# CITY OF CONWAY, ARKANSAS HISTORIC DISTRICT COMMISSION

January 27, 2025 • 5:30pm • 1111 Main Street

- I. **Public Hearing Items - Old Conway Design Overlay District**
  - A. Permanent structure at 2125 Robinson Ave (HDR-1224-0155)
  - B. Garage addition at 344 Conway Blvd (HDR-0125-0002)
  - C. New single-family residence at 346 Ash St (HDR-0125-0003)
  - D. Warehouse addition at 1157 Parkway Ave (HDR-0125-0004)

## Old Conway Design Overlay District

WEST ELEVATION  
1/8"=1'-0"

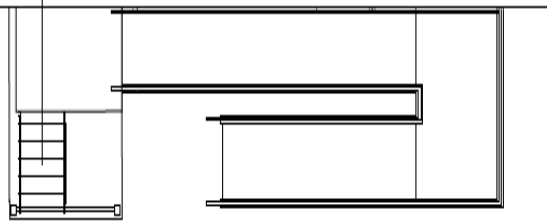
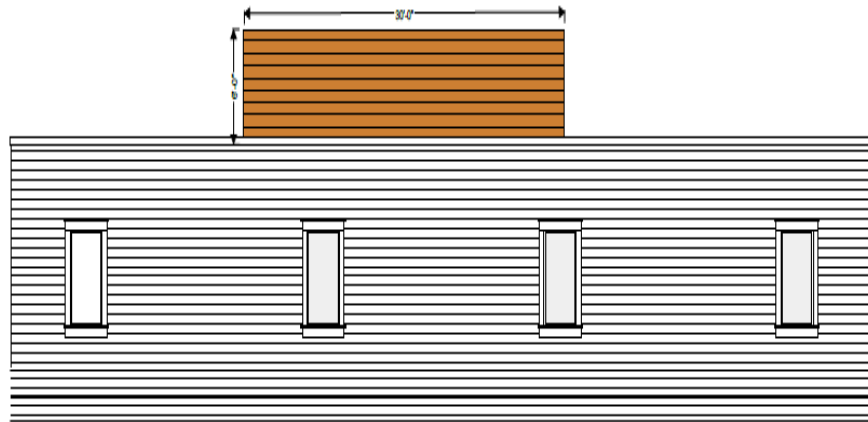
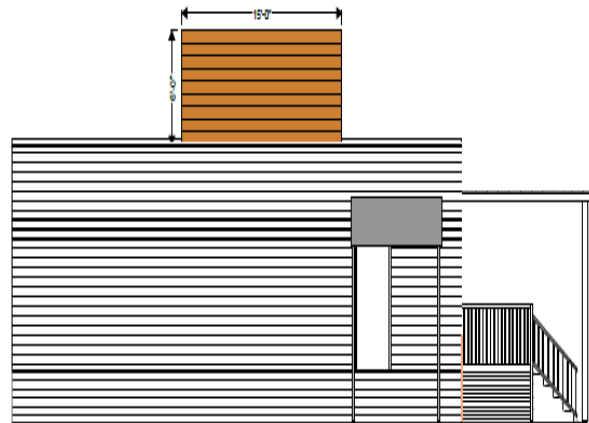
**Façade, wall area, rhythm.** New facades shall be compatible with those of the surrounding area. 25-40% of front façades should contain windows. Window and door openings should relate to the size and proportions contained in the surrounding area.  
*It appears that almost 25% of the front façade contains windows. The Robinson Ave facing elevation does not incorporate 25-40% windows.*

**Entries, Porches, and Porticos, Doors and windows, Awnings.** Porches are encouraged and should be at least 6' deep, when present. Entries should contain special decorative elements and ornamentation.  
*An awning exists above the front porch and on the northern elevation above the tanks.*

**Architectural Details, Siding, and Bricks.** Detailing and siding should complement the surrounding area. Siding should include brick, stone, wood, or Hardieboard/LP Smartside type siding.  
*The structure is currently clad in fiber cement composite. A brick skirt is proposed on the front elevation. The applicant has indicated that additional brick is not feasible.*

**Shutters, Roof, Decks/Plaza Space, Skylights.** Roofing should respect the character of the surrounding area with respect to materials, pitch, and form. Metal roofing is prohibited unless historically used on the structure.  
*The roof does not appear to have a pitch.*

**Mechanical system screening.** HVAC units should be located where they are not readily visible from the street. If visible, they should be screened with shrubbery or fencing.  
*Rooftop screening is proposed. Additional screening of the tanks on the northern elevation is recommended.*

3. Wheel stops at northern end of property shall be removed.
4. Driveway associated with demolished residence shall be removed.
5. Canopy trees shall be planted at a rate of one tree per every 30' of frontage.

6. Shrubs shall be planted along the northeast Robinson Avenue frontage.
7. The area made vacant by the demolition of a residence shall be restored with vegetation.

8. Additional screening of the tanks is required.
9. Trees and landscaping on the eastern side of the property shall be maintained in perpetuity per City of Conway zoning ordinance (Article X, Sec. 1007.9.A.4.a.-b.)

New Garage  
 5' Off North Building  
 Line & 16' Off East  
 Property Line

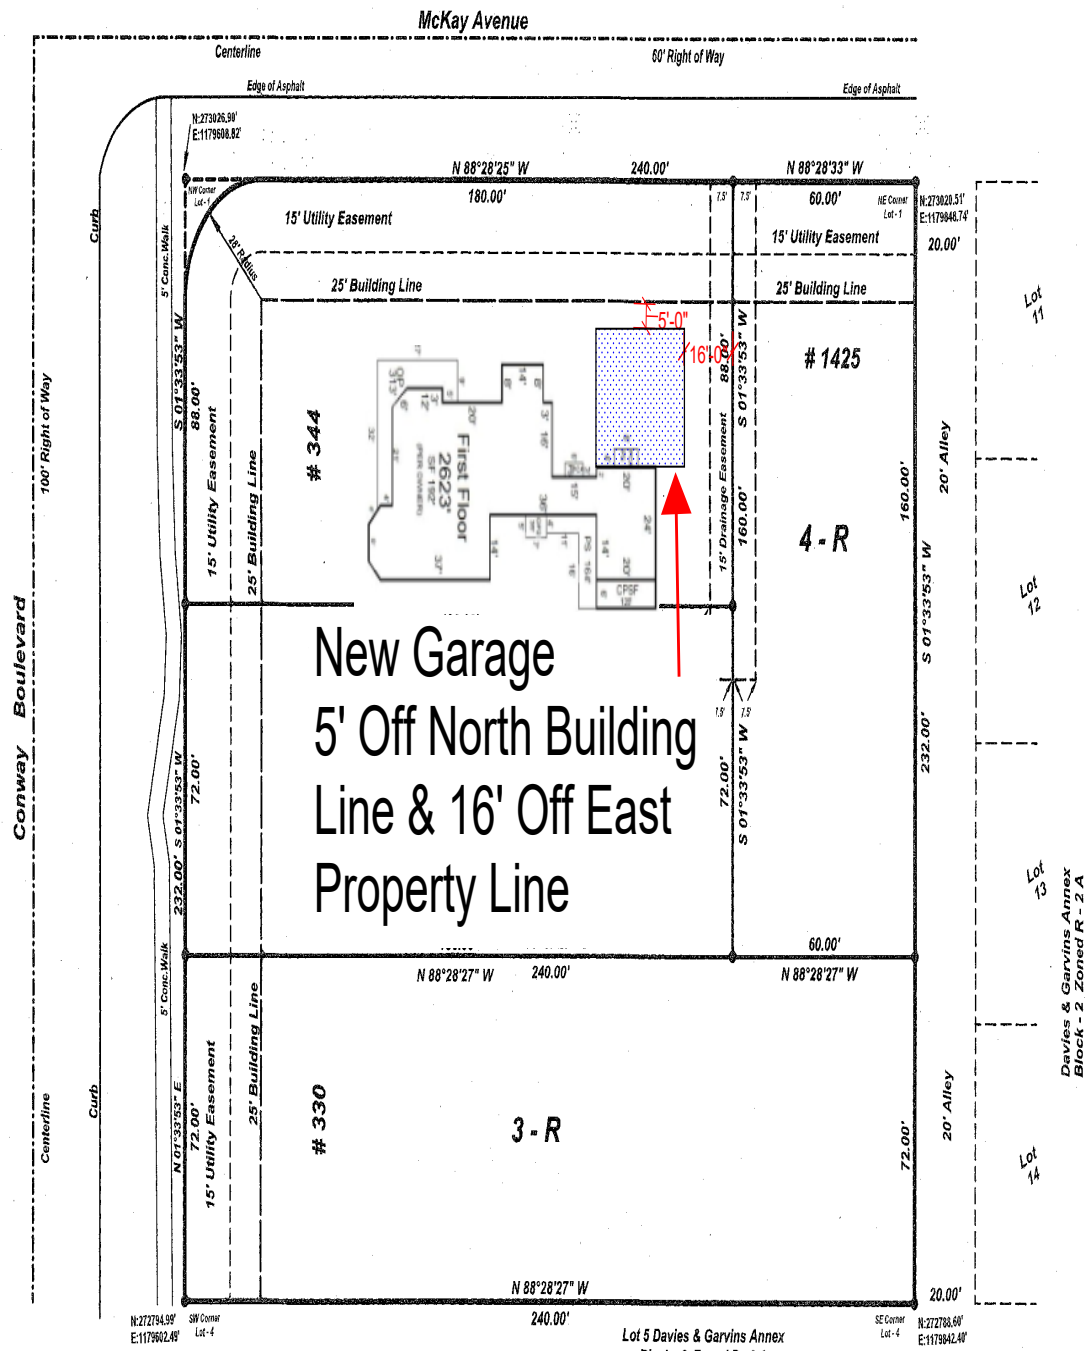
*The addition is depicted as having a 30ft secondary setback and a 16ft rear setback. The proposal conforms.*

*The garage addition's height is not indicated on the elevations but is shorter than the 2014 addition and similar in height to the existing single-family residence.*

*Similar to the complexity of form, there is no uniform façade design in the area. The proposal contributes to the rhythm of the existing architecture. There are two garage doors proposed. Windows are proposed on both the east and west elevations of the garage addition.*

*The pitch of the garage roof respects the pitch of the existing structure.*

2. Lighting shall be downward and inward toward the property.

3. Construction shall match that shown on the site plan and elevations.

<b>ELEVATIONS</b>		
Project Name:	Project Number:	<b>A400</b>
Date:	Issue Date:	
Drawn by:	Author:	
Checked by:	Checker:

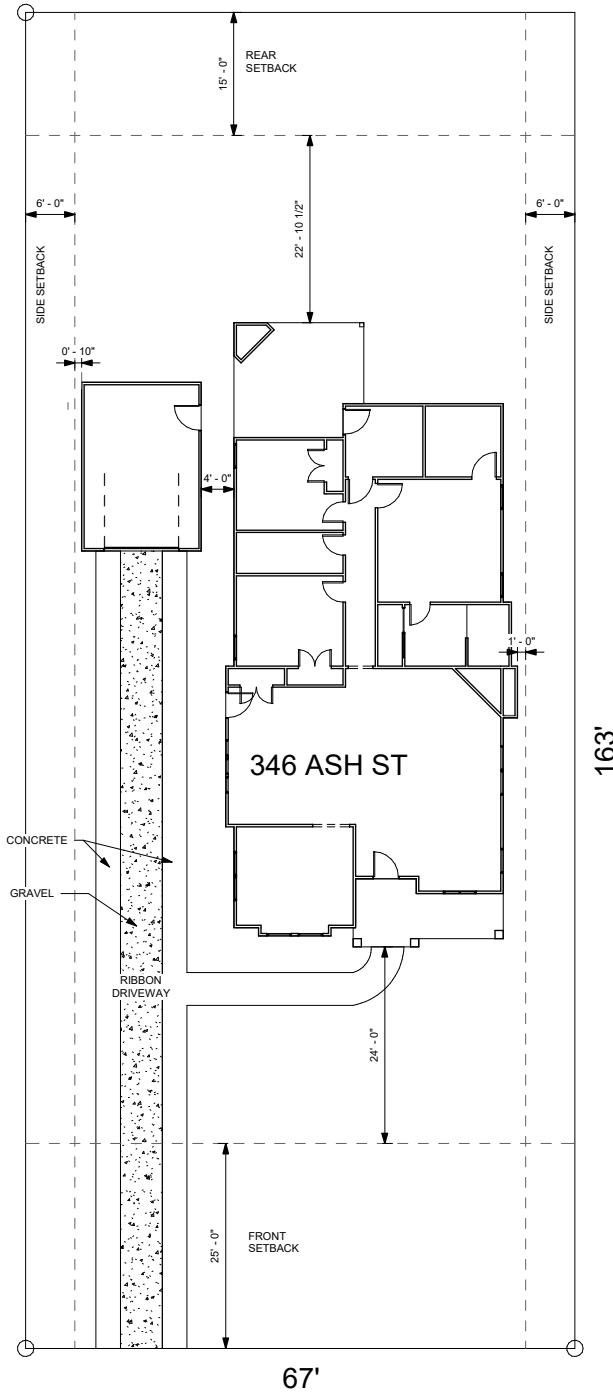
*The predominant front setback is 25' from right-of-way. The applicant is proposing a setback of 49'. This is in excess of the average for the area. Right-of-way does not appear to have been dedicated yet. The front setback needs to be between 20 and 30 feet from right-of-way. The project is conditioned to ensure this.*

*Northern side yard abuts a 10' alley. The proposed garage is 6' from the side yard which equates to 11' from the centerline. The eastern side yard setback conforms to 6'. The rear setback conforms.*

*The rear elevation lacks windows at the location of the laundry room, master closet and one bedroom. This elevation faces an empty lot owned by Central Baptist University. The rear elevation of the proposed residence is visible from Center Street.*

*Lighting is not indicated on submitted plans.*

*No HVAC equipment is shown on the site plan.*

3. Property shall be replatted prior to building permit issuance.
4. Prior to issuance of a Certificate of Appropriateness, applicant shall submit for review by Planning & Development staff a site plan showing:

- Appropriate front and side yard setbacks.
  - Lot coverage tabulation with driveway and internal sidewalks.
  - Tree removal, retention and plantings.

- Sidewalks and greenspace in right-of-way.
5. Driveway shall be concrete, pavers, or permeable paving.
6. A 5' sidewalk with 6.5' greenspace is required.

7. Lighting shall be downward and inward toward the property.
8. HVAC equipment shall be screened from public view.

**ARCHITECTURAL SITE PLAN**  
3/32" = 1'-0"

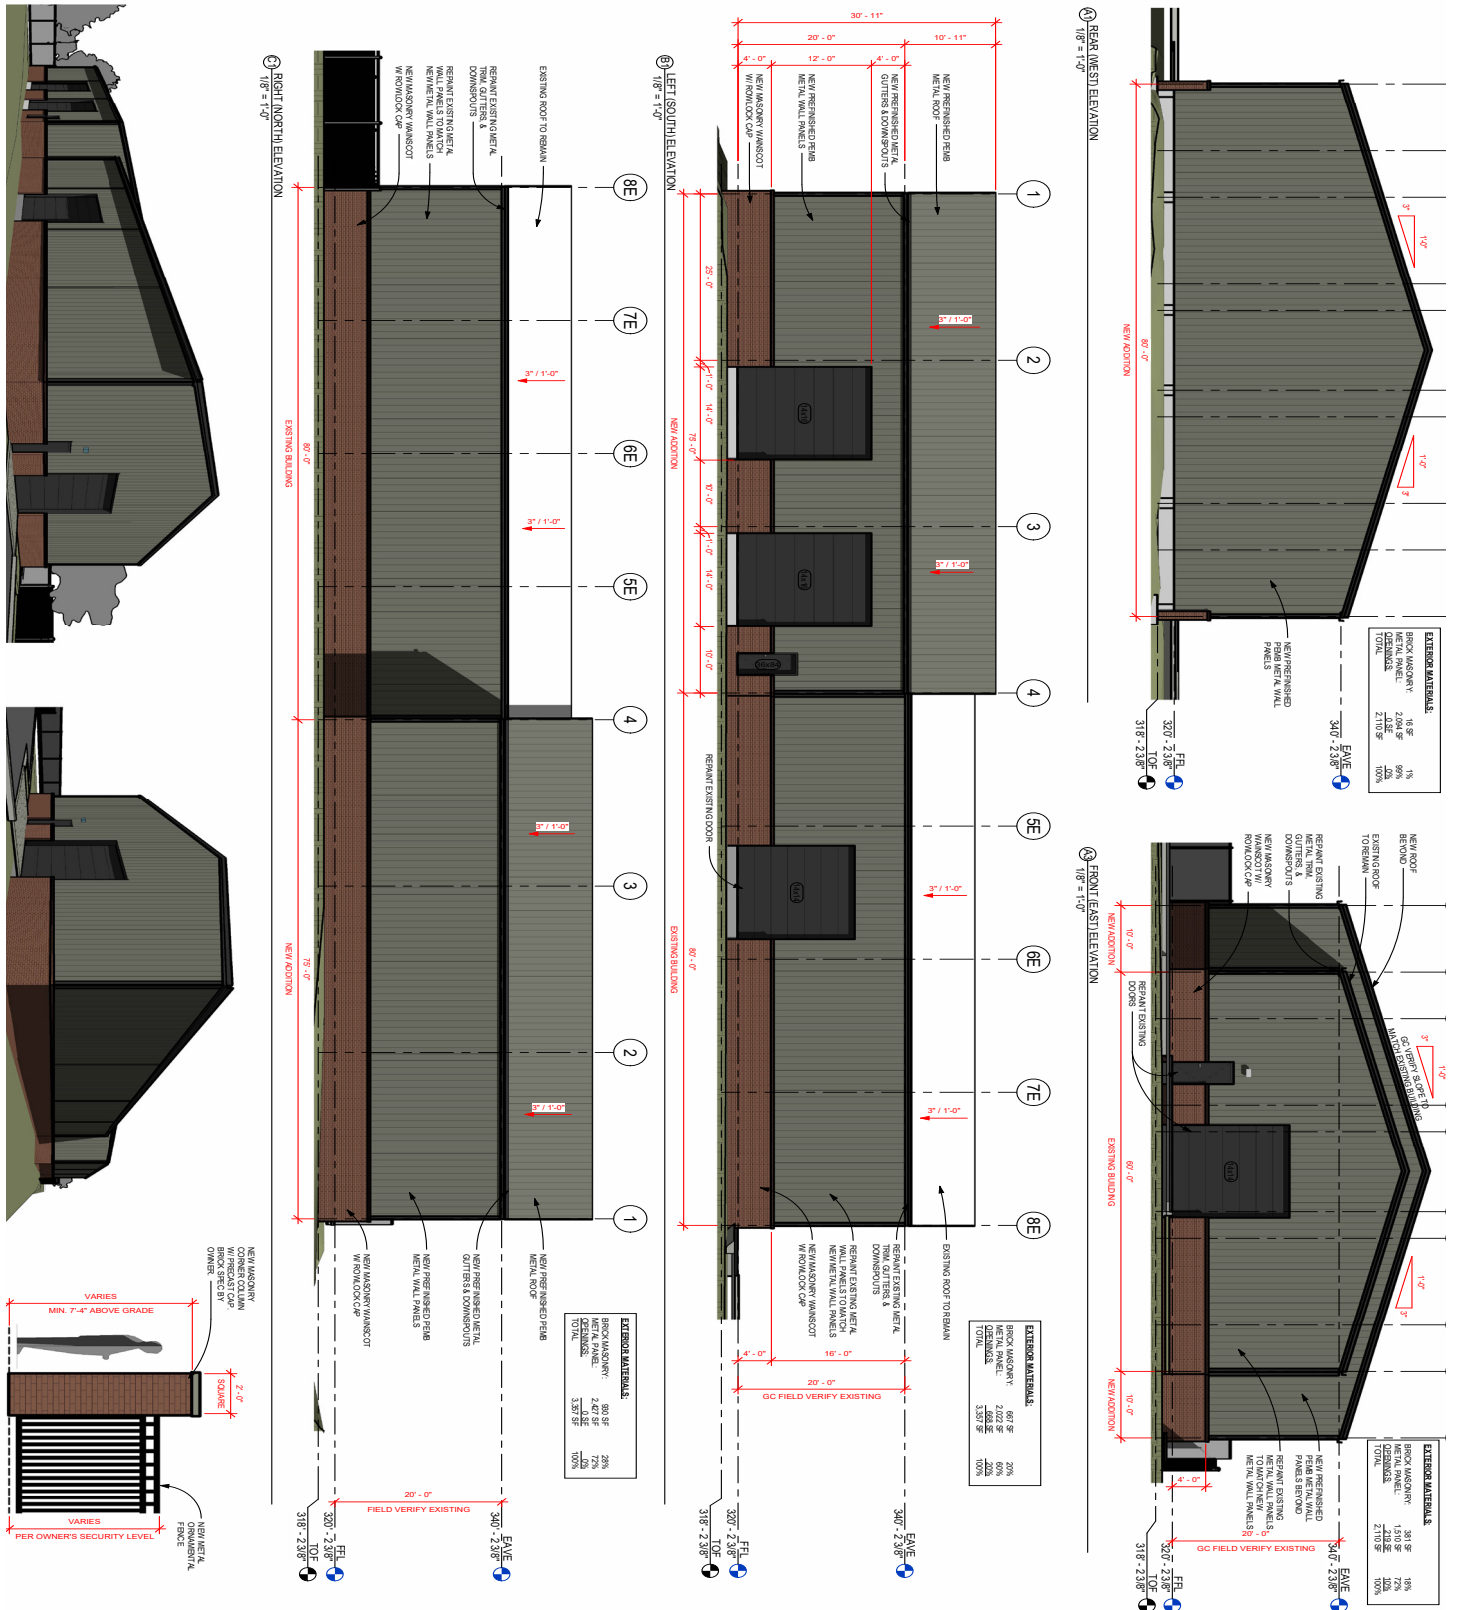
*Setbacks are not indicated on the site plan, but the design appears to conform. The existing building is along the front of the property and the rear setback appears to be at least 15'. Applicant should confirm during Post Site Development Review.*

**Building Height.** Primary structures within the Urban Transition Zone shall be no greater than three and one-half stories in height. *The proposed structure is 30ft tall. This conforms as one would expect a three-story structure to be between 30ft and 40ft.*

*The applicant did not include this information in submittal package. Civil plans from Site Development Review indicate that the total area of impermeable surface is 47% and the proposal conforms.*

*Metal ornamental fencing is proposed along the street frontage and along the side yards for about 60'. In order to better screen and enhance the sites articulation, brick corner posts are proposed. Security fencing should not be visible from the public right-of-way, where feasible.*

1. Applicant must obtain all applicable building permits\* if/when a Certificate of Appropriateness is granted.  
*Applicant shall provide proof of appropriate licensure of professionals performing work to the Building Permits Department.*
2. Applicant must complete Post-Site Development Review and include drawings which show the setbacks and lot coverage tabulation. This must be completed prior to Certificate of Completion being issued.
